County of Fairfax, Virginia

Re: RZ 2001-BR-022, Fairfax Gateway, Rear Yards, Proffer Interpretation PI 0609 139

RE: Fairfax Gateway
Request for Letter of Interpretation (RZ 2001-BR-022)
Project #003105.00

SETBACK EXHIBIT

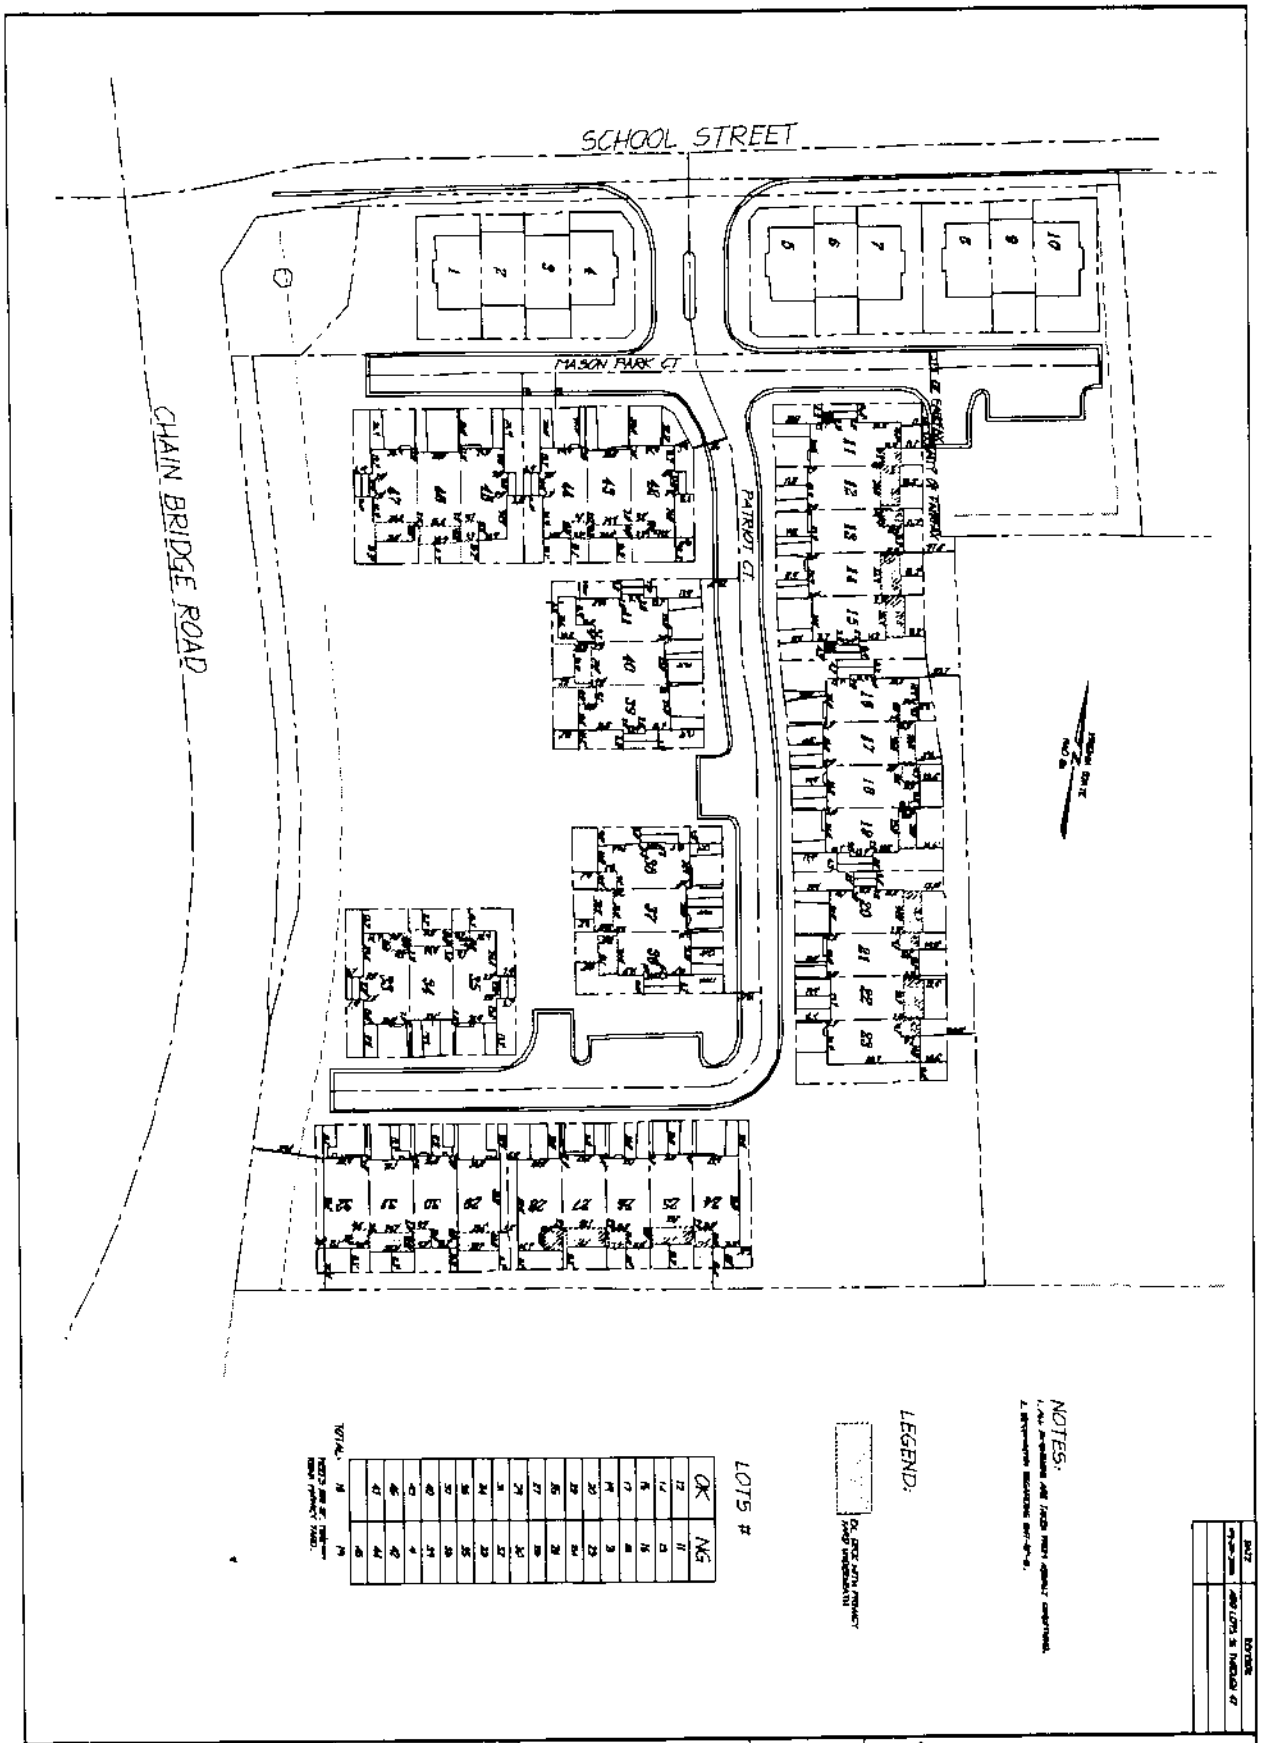
Relative to the specific issue at hand, the approved CDP/FDP has some conflicting information. The conflict appears on sheet 41 (as attached from the approved site plan) and on the site plan (sheet 39). The detail is entitled: "Unit Detail Fairfax County" drawn at a 20 scale and so noted. When you add the 15' rear dimension to the 51' house footprint (including 8' sunroom) and an 18' front yard, the lot would need to be 84' deep. On the site plan the lots scale only 82' in depth with rear setbacks of 12' and 14'. The unit detail is on sheet 3. The approved final site plans used the same lot geometry and unit sizes (see sheet 10), which also scale as a 12' and 14' rear setback. Hence we have a conflict between the typical section and the layout on the site plan sheet. There are also a few atypical lots as shown on the approved CDP/FDP which when scaled have significantly less rear yards (a minimum of 5' on lot 16) due to the angled rear lot line. All of the rear yards as constructed (please see attached "Setback Exhibit" by christopher consultants, dated 7/27/06) are similar in feel to the approved CDP/FDP and final site plans. The 13'+/- and 15'+/- can vary up to 1.9' less than those dimensions. However, when taken from the scaled dimensions on the approved CDP/FDP and final site plans they vary by less than 1'. Please see attached spreadsheet for a lot-by-lot comparison of the rear setback from the approved CDP/FDP and the as-built conditions. All of the rear yards do meet the minimum requirement of a 200 SF minimum privacy yard as well as the height and bulk plane of the overall site boundary (see attached exhibits).

The CDP/FDP contains an illustration of a typical single family attached dwelling lot, which includes yard dimensions and landscaping. The CDP/FDP also includes setbacks between the proposed dwelling units and the property line for the rezoning application. It is my understanding that all of the dwelling units meet the setback from the rezoning application property line shown on the CDP/FDP. I have reviewed the rear yards shown on the approved site plan and as summarized by the chart attached to your letter. It is my determination that the rear yards shown on Site Plan 1847-SP-01-2 are in substantial conformance with the proffered CDP/FDP for RZ 2001-BR-022. This determination has been made in my capacity as Senior Deputy Zoning Administrator.
